Notice No. 7
June 17, 2026

PRE-PROPOSAL QUESTIONS & ANSWERS

RFP N62742-26-R-1306
JFY 2022 PROJECT J-875, BATTLE STAFF TRAINING FACILITY,
U.S. NAVSUPPACT MCB CAMP BLAZ, GUAM

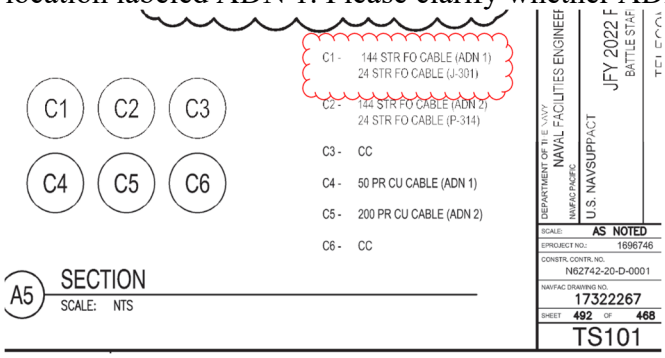
85. Reference: Solicitation-N6274226R1306 Dwg TS101
On Dwg TS101, Section A5 indicates that the C1–144 STR FO cable runs up to the Area Distribution Network location, noted as ADN 1. However, the drawing does not show any location labeled ADN 1. Please clarify whether ADN 1 refers to the same location as J-301.

ANSWER: The 144 STR FO cable provided by J-875 goes to TMH-503, where it is spliced to an existing cable inside TMH-503. Refer to Sheet TN601, which shows the existing (shaded) cables and splice cases in TMH-503. ADN-1 is where the existing cable in TMH-503 originates. ADN-1 is not the same location as J-301; the location of J-301 is shown on Sheet TS100.

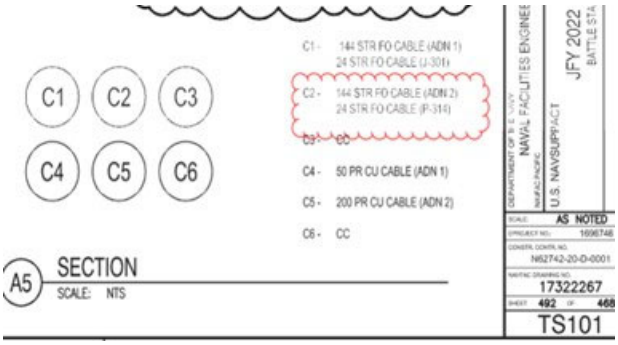
86. Reference: Solicitation-N6274226R1306 Dwg TS101
On Dwg TS101, Section A5 indicates that the C2–144 STR FO cable runs up to the Area Distribution Network location, noted as ADN 2. However, the drawing does not show any location labeled ADN 2. Please clarify whether ADN 2 refers to the same location as P-314.

ANSWER: Similar to Q85, the 144 STR FO cable provided by J-875 goes to TMH-503, where it is spliced to an existing cable inside TMH-503. Refer to Sheet TN601, which shows the existing (shaded) cables and splice cases in TMH-503. ADN-2 is where the existing cable in TMH-503 originates. ADN-2 is not the same location as P-314; the location of P-314 is shown on Sheet TS100.

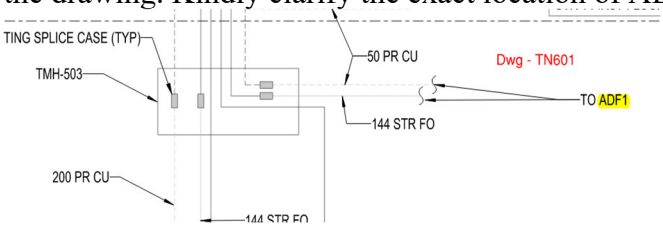
87. Reference: Solicitation-N6274226R1306 Dwg TN601
Dwg TN601 indicates that the 144 STR FO cable and 50 PR CU cable run from OSP/ISP Voice through TMH-503 to the ADF1 location. However, no location labeled 'ADF1' is identified on the drawing. Kindly clarify the exact location of ADF1.

ANSWER: The 144 STR FO cable and 50 PR CU cable provided by J-875 go to TMH-503, where they are spliced to existing cables inside TMH-503. TN601 shows the existing (shaded) cables and splice cases in TMH-503. ADF-1 is where the existing cable originates.

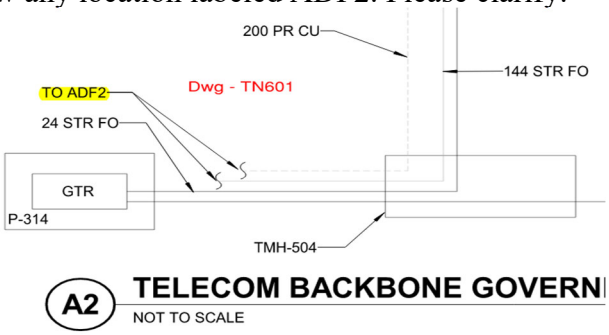
88. Reference: Solicitation-N6274226R1306 Dwg TN601
On Sheet TN601, it is indicated that the 144 STR FO cable and 20 PR CU cable run from OSP/ISP Voice through TMH-504 up to the ADF2 location. However, the drawing does not show any location labeled ADF2. Please clarify.

ANSWER: Similar to Q87, the 144 STR FO cable and 200 PR CU cable provided by J-875 go to TMH-503, where they are spliced to existing cables inside TMH-503. TN601 shows the existing (shaded) cables and splice cases in TMH-503. ADF-2 is where the existing cable originates.
